## DEVIATION REQUEST AND DECISION FORM

Project Name : Trails at Aspen Ridge Filing No. 2  
Schedule No.(s) : 5500000412  
Legal Description : Unplatted Land

A deviation from the standards of or in Section **Section 3.3.1** of the Engineering Criteria Manual (ECM) is requested.

SEAL				
<b>TRAILS AT ASPEN RIDGE</b>				
FILING NO. 2				
ROADWAY & STORM IMPROVEMENT PLANS				
<b>STORM DRAIN PLAN &amp; PROFILE</b>				
DESIGNED BY: NMS	SCALE: HORIZ 1" = 40'	DATE ISSUED: FEBRUARY, 2020	DRAWING No. SD01	
DRAWN BY: CRD	VERT. 1" = 8'	SHEET 31 OF 36		
CHECKED BY: NMS

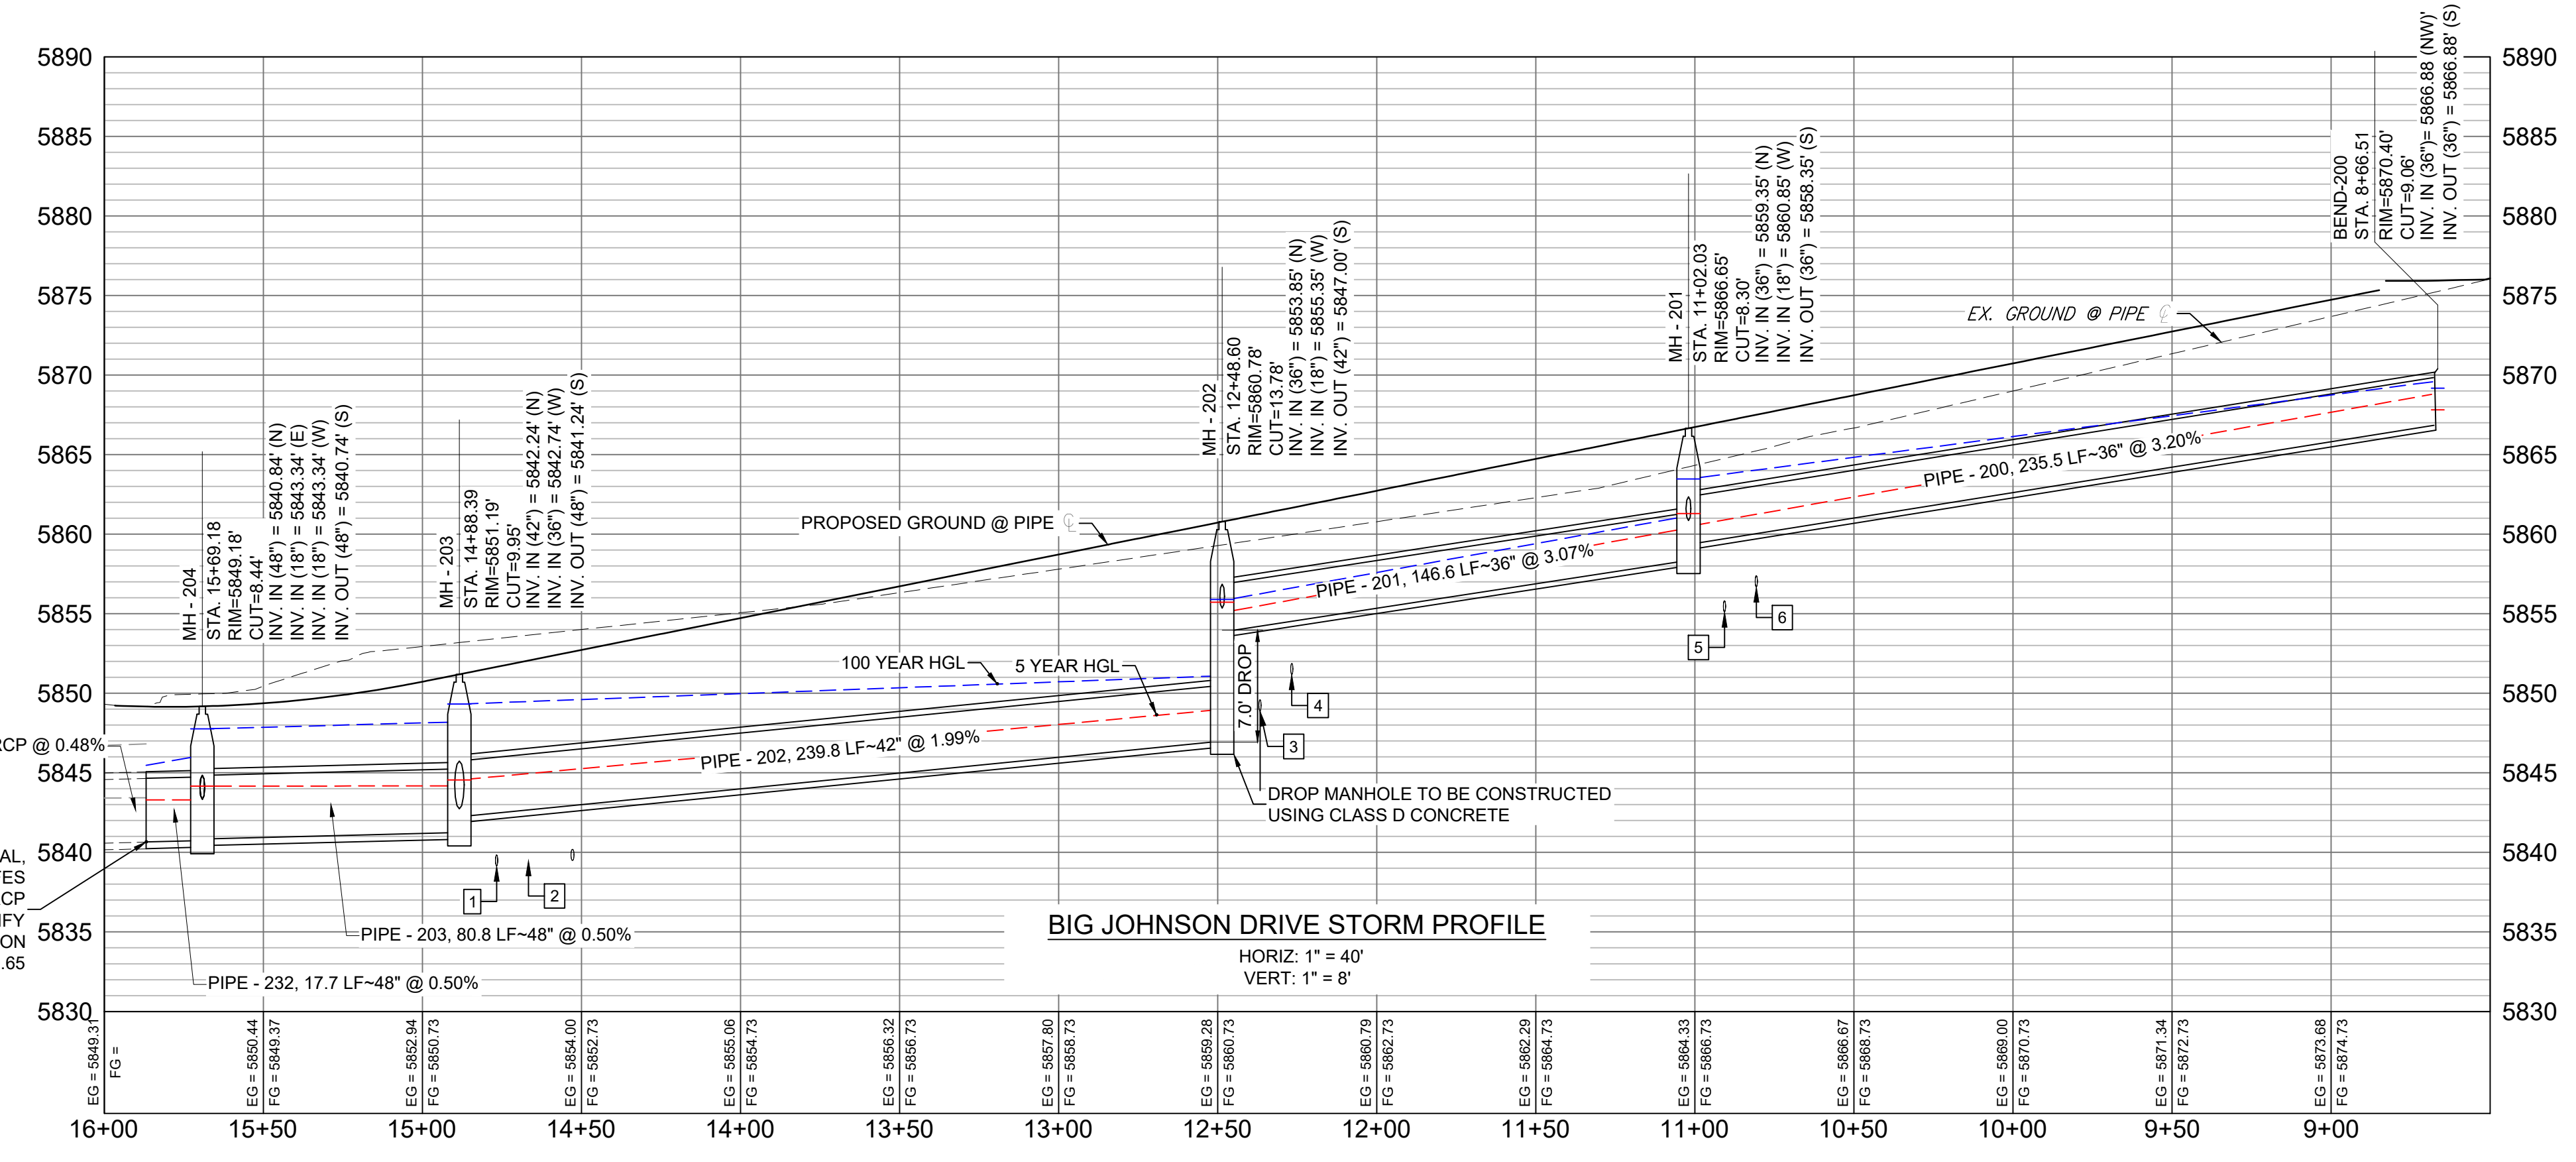
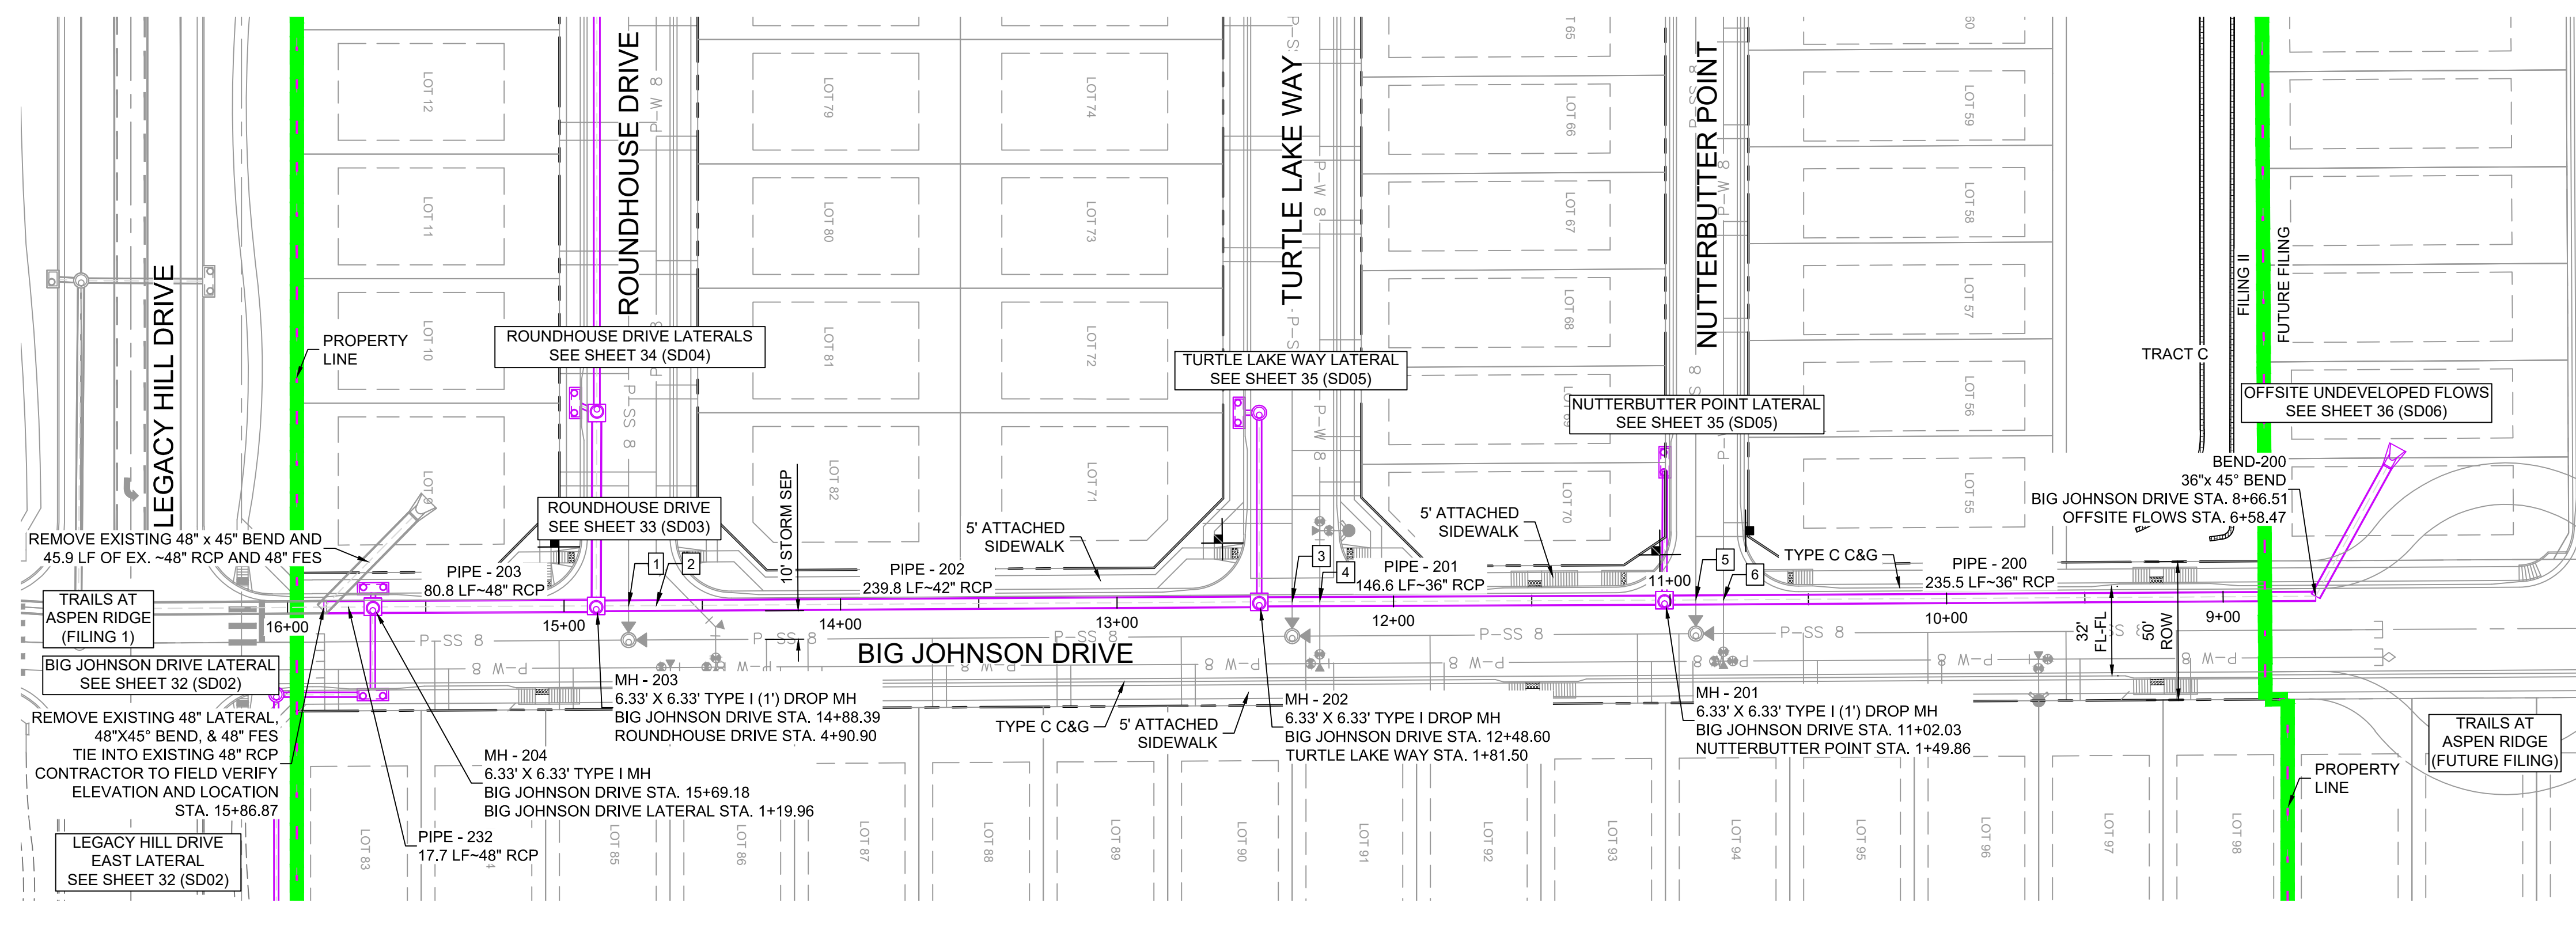
Storm MH-202 - A drop greater than one foot is necessary to provide acceptable velocities within the proposed storm sewer, aid in hydraulic loss which could result in HGL values out of compliance with ECM standards, avoid upstream utility conflicts (sanitary sewer and water) and to optimize the elevation at which the storm sewer enters the proposed East Pond full spectrum detention pond for the proposed development.

The proposed sanitary sewer presents a challenge for the installation of the storm sewer. Without the drop manhole storm sewer will be placed in deep installations (greater than 18 feet) due to the size of the pipe and to avoid sanitary sewer service conflicts of the existing sanitary sewer. By using the drop manholes, the storm sewer is above the services within Big Johnson Drive with a more conventional installation and the deep sewer installation is limited to short segments. Drop manholes in excess of 1-ft have been approved under the DCM Volume 1 for similar situations within adjacent municipalities. Drops greater than 1-ft require additional concrete strength and scour protection which is proposed with this design in the form of Class D concrete for the manholes and provision of a 1' sump for energy dissipation.

By raising the upstream storm pipe to avoid utility conflict with proposed sanitary sewer, and by lowering the downstream pipe to reduce pipe velocities/HGL's to within acceptable range, the 7.0-foot drop meets the design intent and purpose of the ECM standards.

This request has been determined to have met the criteria for approval. A deviation from Section 3.3.1 of the ECM is hereby granted based on the justification provided.

Concrete Class S35 (a 5000 psi mix) shall be used.
